## **REPORT FOR CONSIDERATION AT PLANNING SUB-COMMITTEE**

**Reference No:** HGY/2014/3409

**Address:** Park Road Swimming Pools Park Road N8 7JN

**Proposal:** Retrospective application for change of position for new flue. New roof mounted fence to screen flue and roof plant.

Location of boiler flue

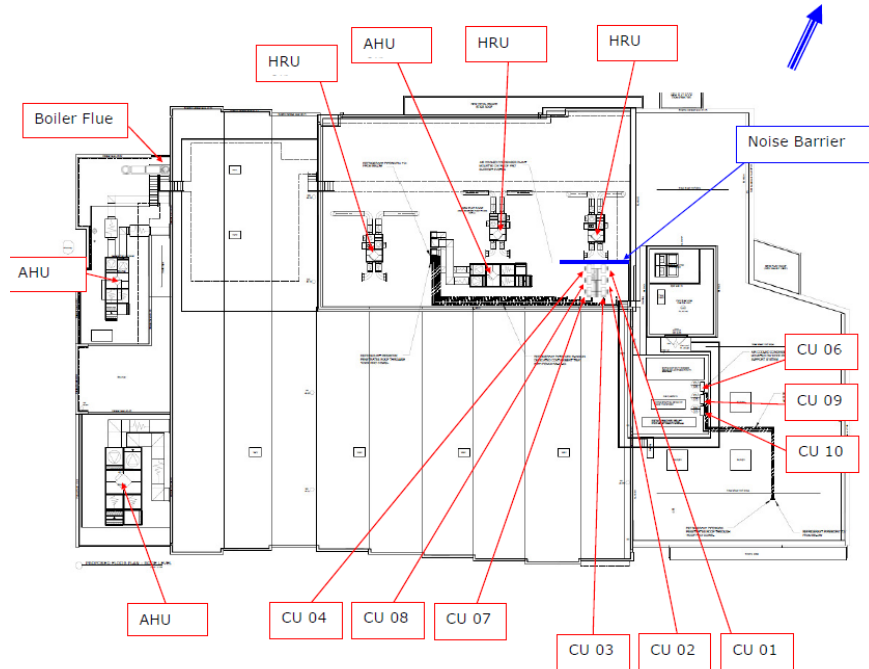
Consultation Responses	Comment
<p>Position and height of flue and associated exhaust fumes reaching neighbouring building Fuller Court.</p>	<p>The flue in question is needed for the day functioning of this leisure facility with its location influenced by the internal arrangements of the building (i.e. the location of the plant room). The location of the flue and measures to minimise its appearance are considered acceptable.</p> <p>The applicant confirms that the design of the heating system and flue is compliant with the Clean Air Act 1993. The emission that has been referred to as 'smoke' is water vapour produced as a result of the boiler's operation.</p> <p>A copy of the Clean Air Act Memorandum calculation from the actual flue manufacturer/installer was provided to the Council. This calculates that the height of the flue should be 9.6m. The applicant (Fusion) has also confirmed that it has carried out a check calculation, using industry standard software and ascertained a similar height to the manufacturer. The flue termination has been installed at 9.6m. The various calculations/ information have sent to the Council's Environmental Health team who indicate that LA approval is not needed for this particular installation under the Clean Air Act 1993.</p> <p>This information submitted adequately demonstrates that flue installation in question is in compliance with the guidelines set out in the Clean Air Act Memorandum.</p>

Roof plan as approved ref: HGY/2013/1500

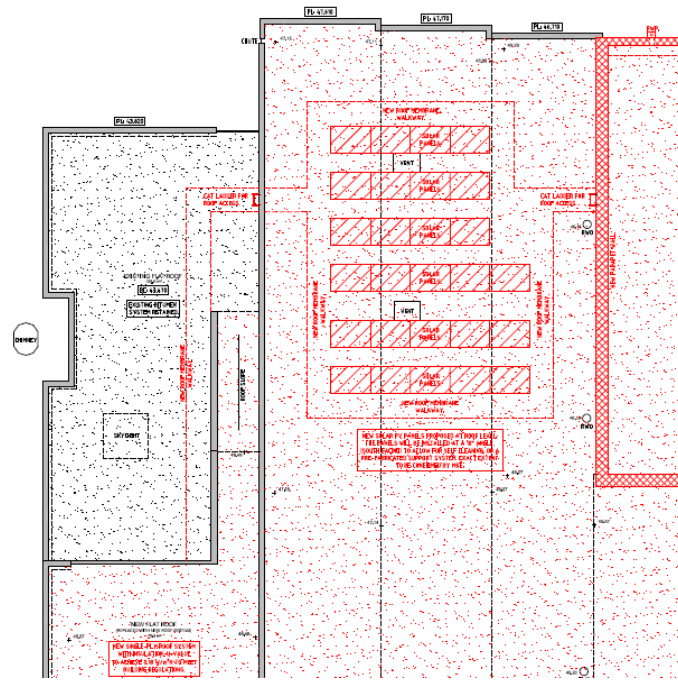
Location of boiler flue – Top left corner
